From: Lasley, Timothy G
Sent: Thursday, August 22, 2019 11:59 AM
To: gjackmail@gmail.com
Cc: Werner, Jeffrey B
Subject: BAR Action - August 20, 2019 - 601-617 East Market Street

BAR 19-07-05
601-617 East Market Street
Tax Parcel 530100060
Allan H. Cadgene, Owner/Greg Jackson, Applicant
Construction of Plaza Pavilion

**CITY OF CHARLOTTESVILLE
BOARD OF ARCHITECTURAL REVIEW
STAFF REPORT
August 20, 2019**

BAR 19-07-05

COURTYARD PLAN

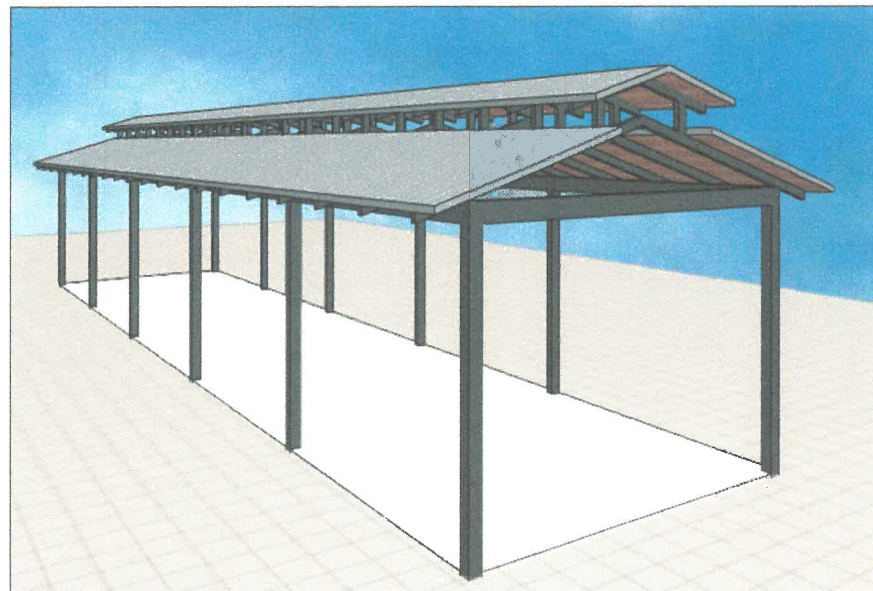
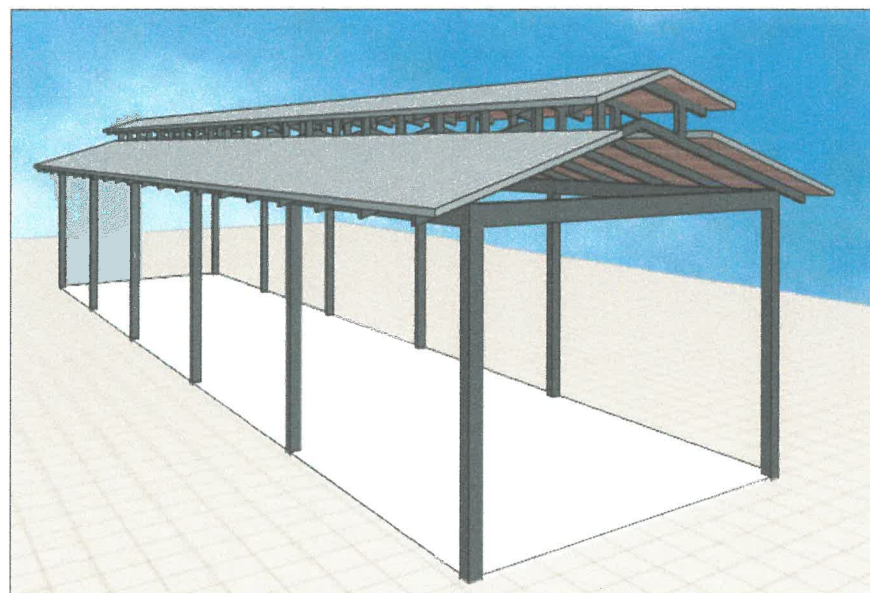
landscape:
existing trees to remain and be trimmed, treated and protected, patio to be a permeable paving design and sloped to direct runoff to drains. half of pavilion roof runoff is directed to the raised crape myrtle area and other half of roof runoff falls to new permeable patio and ground gutter.

1. Existing conditions that include compacted and bare soil with no groundcover, turf, or mulch are contributing to erosion and stormwater runoff issues existent on site. This situation reduces the amount of water that can permeate into the soil, creating high amounts of overland flow that carry and deposit soil and debris to the walk below.

2. Ensuring downspout to drain connections are remedied on neighboring building will lessen stormwater impact on courtyard.
3. Permeable paving, using either new pavers or salvaged brick found on site, can be used to mitigate stormwater flow from proposed pavilion roof, acting as a ground gutter and allowing normal rain events to be absorbed into the gravel bed beneath pavers, and percolate into the ground.

4. Proper grading of pavilion hardscape and use of shredded hardwood mulch on existing trees will further control stormwater runoff from proposed building site, directing overflow to existing channel drains.

5. Half of the proposed pavilion drainage will deposit into the raised planting area containing the Crape Myrtles, redirecting rain that previously fell on the courtyard area.

- **Ensuring downspout to drain connections are remedied on neighboring building will mitigate stormwater impact on courtyard;**
- **The use of a permeable paving system as recommended on both letters;**
- **Using proper grading of pavilion hardscape, and the use of shredded hardwood mulch on existing trees;**
- **The use of soil injects nutrients before construction and after final grading;**
- **Pruning the roots before construction starts;**
- **The installation of tree protection fencing.**
